TECHNICAL SERVICE BULLETIN

Seat Pan Looseness, Lateral Movement, And/Or Clunk/Thump Noise On Turns

22-2101

Lincoln
2017-2020 Continental
2018-2022 Navigator

Figure 1

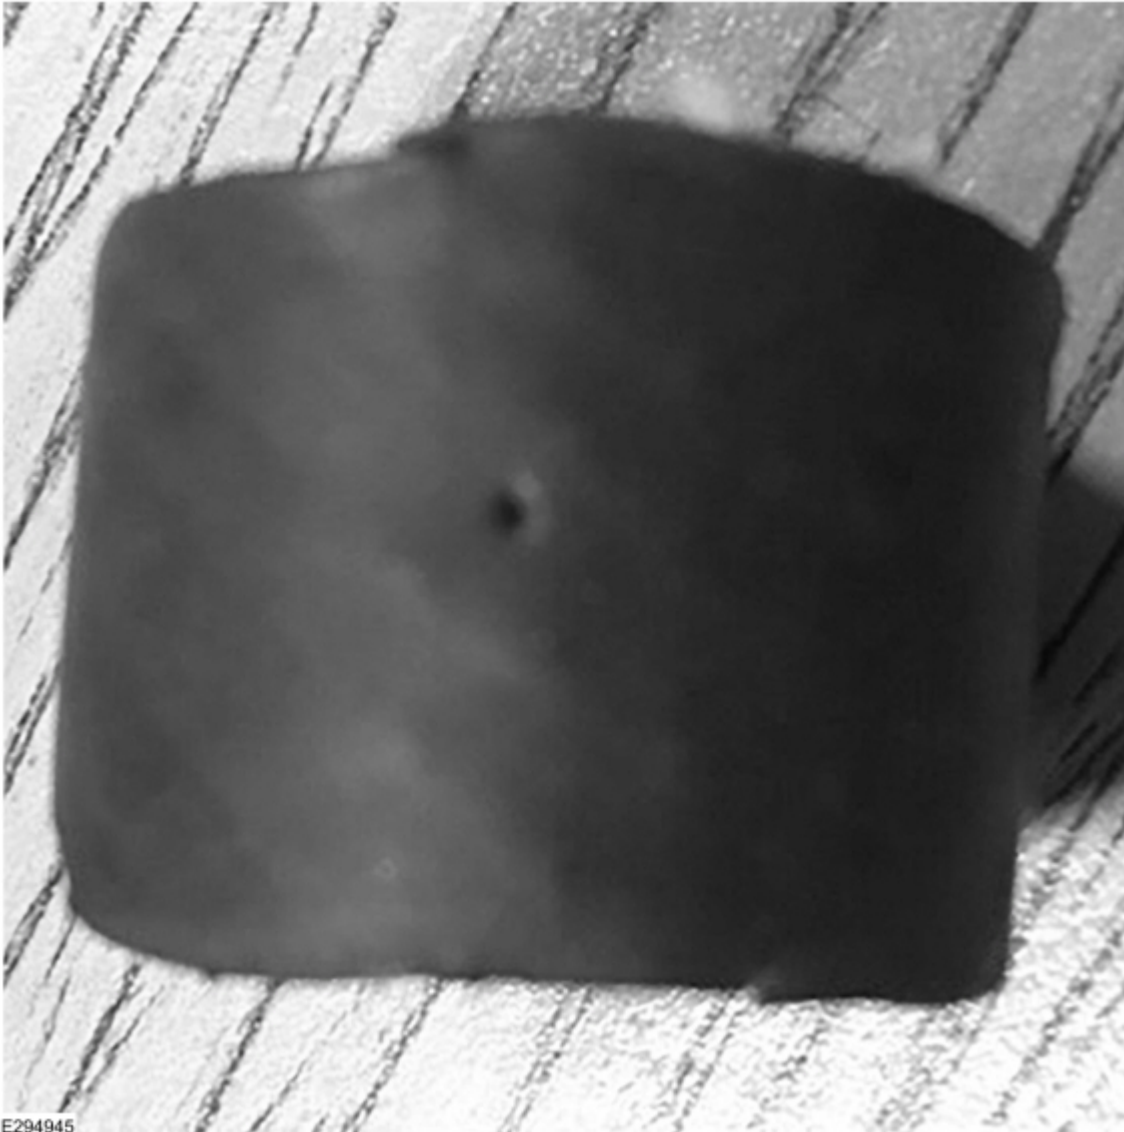
2. Remove the driver front seat module (DSM) and passenger front seat module (SCMB). Refer to Workshop Manual (WSM), Section 501-10A.
3. Remove the seat module mounting bracket.
4. Cut a 25.4 mm (1 in.) long piece of 19 mm (3/4 in.) diameter heater hose. (Figure 1)

Figure 3

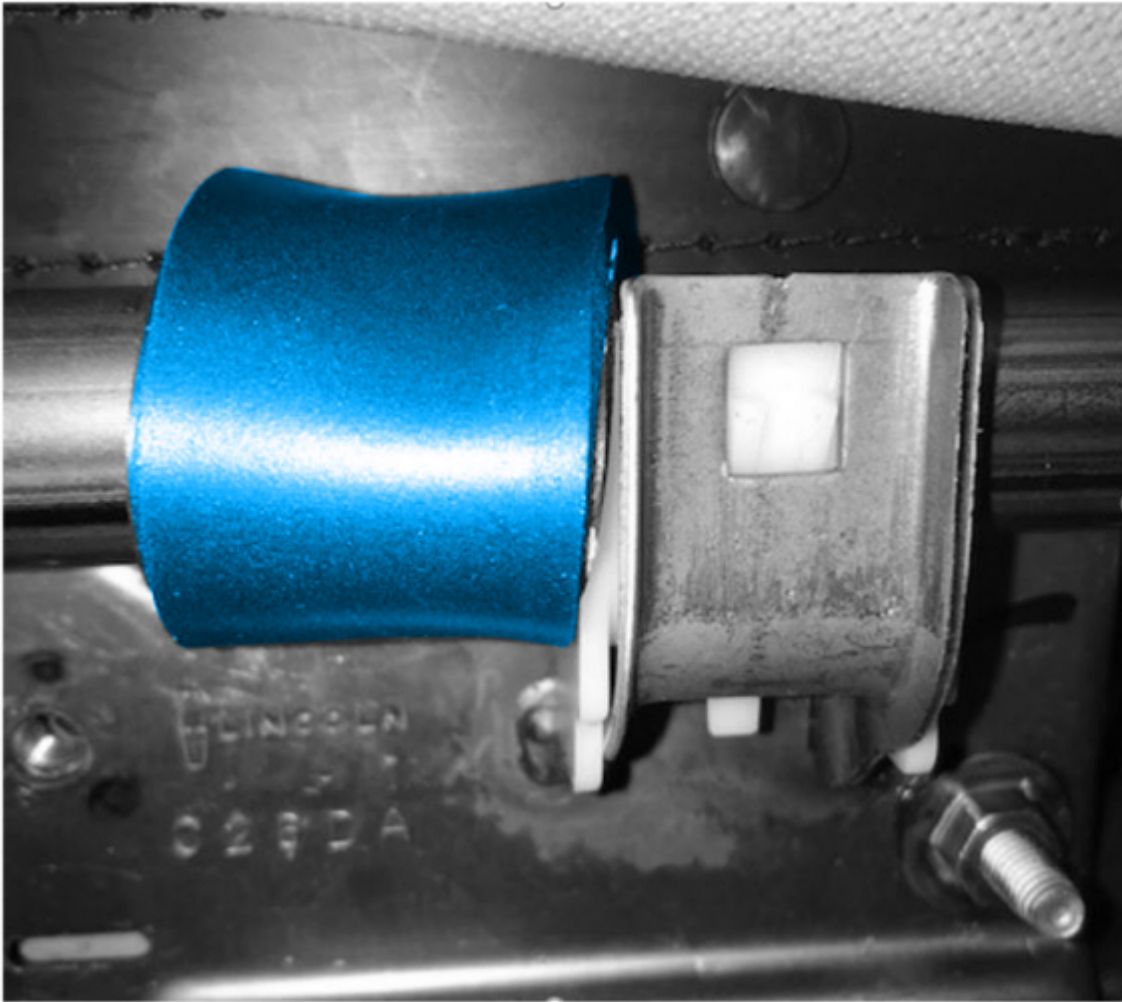
6. Install the hose over the front cross tube. (Figure 3)

Figure 4

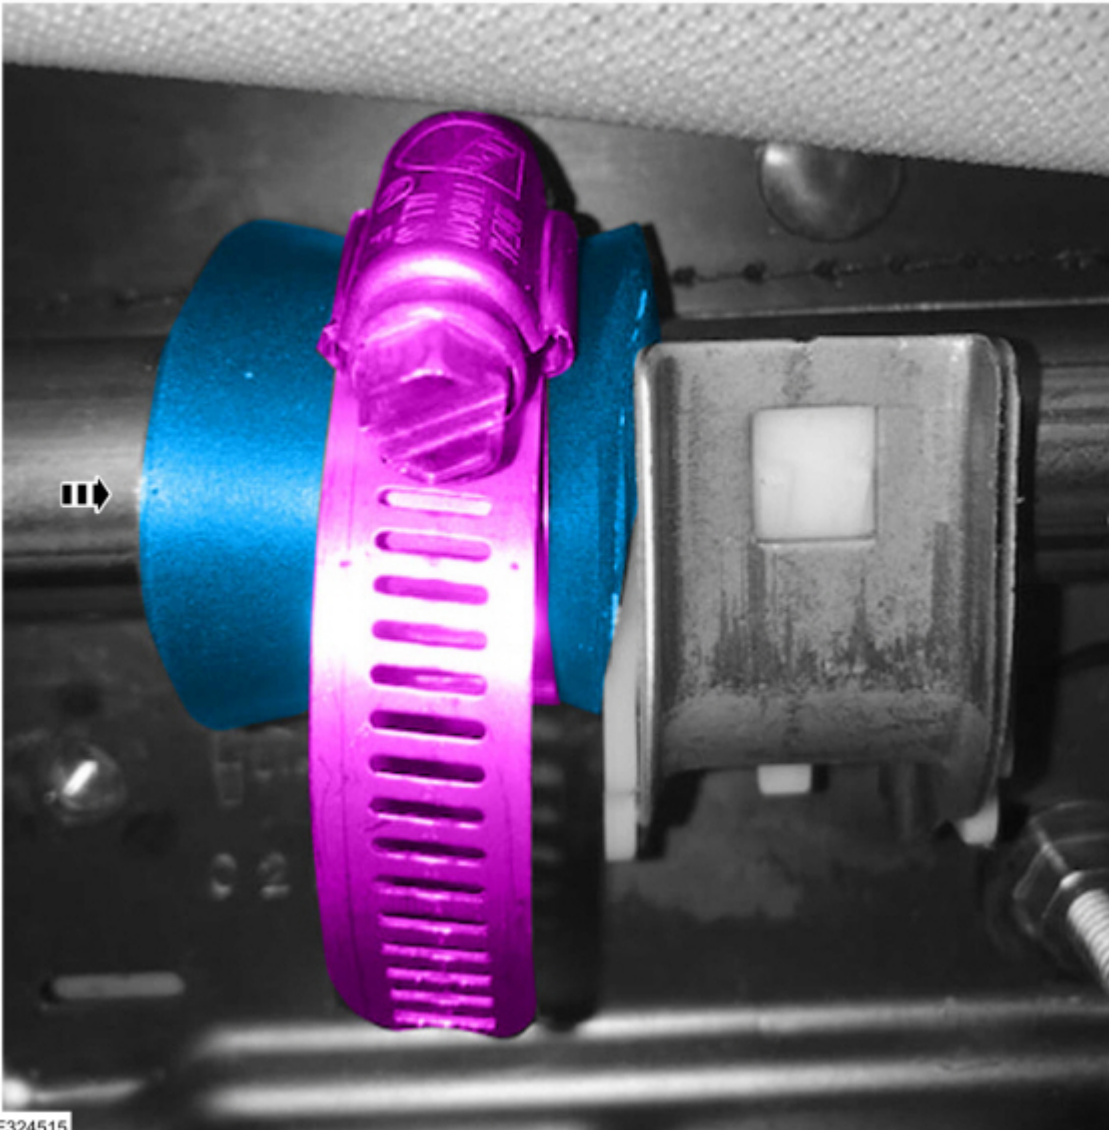
7. Open the hose clamp and slip the hose clamp over the heater hose, securing the heater hose to the front cross tube.

8. Push the heater hose against the cushion hook and tighten the hose clamp to 3.7 Nm (33 lb-in). (Figure 4)
